COUNTY OF LOUDOUN  
Department of Planning

**DATE:** January 12, 2011  
**TO:** Loudoun County Board of Supervisors  
**FROM:** Evan Harlow, Project Manager  
Julie Pastor, AICP, Director  
**SUBJECT:** **January 19, 2011 Transportation and Land Use Committee Meeting  
ZMOD-2010-0002; Webb Buffer Easement**

**View west toward SWM Pond (9 off-site evergreens)**

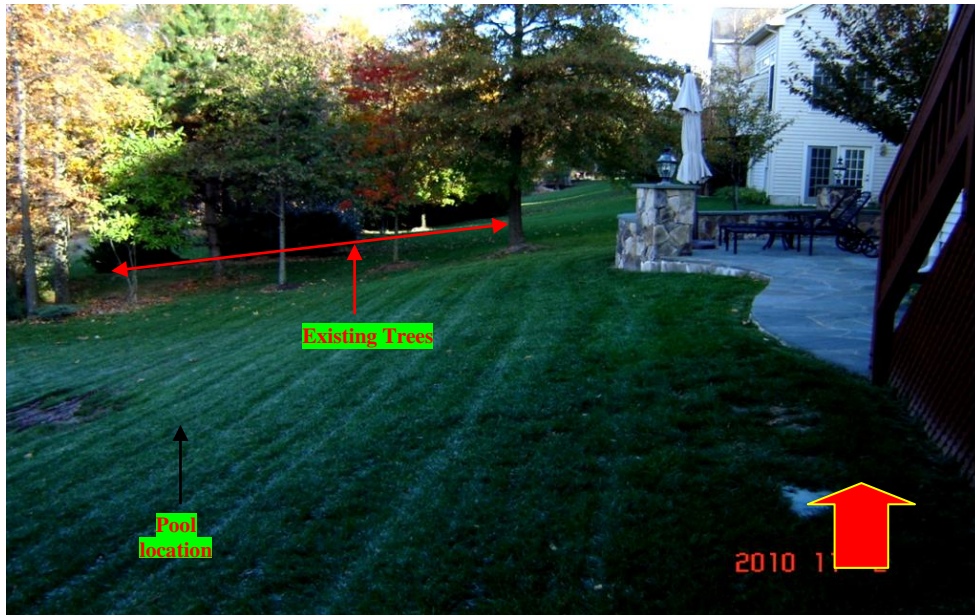
Lot 33 to the west contains a large dry pond previously constructed for the retention of stormwater runoff from adjacent Section 20 of Broadlands. A stormwater management easement exists around the limits of the dry pond that limits disturbance in this area. The easement area fundamentally acts as a no-build buffer of approximately 130' between the rear property line of Lot 6, extending west into Lot 33. In addition to the stormwater management easement, a 50' Buffer Yard, planted with 9 evergreen trees is provided along the eastern boundary of Lot 33, adjacent to Lot 6. The closet portion of the home on Lot 33 lies approximately 180' from the rear property boundary of Lot 6.

Staff concludes that the project has not justified how the encroachment into the buffer yard achieves an innovative design, improves upon the existing regulations, or otherwise exceeds the public purpose of the regulation. However, Staff does find that the 50' buffer yard easement was originally established with Section 20 to provide a buffer from the lots with a lower residential density in Section 21 to the west and that the 130 foot eased area accompanied by nine (9) off-site evergreen plantings, the existing on-site trees, and the 4 foot high fencing around the perimeter of the property provides sufficient building area separation and landscape screening that adequately mitigates the pool encroachment from adjacent Lot 33 to the west.
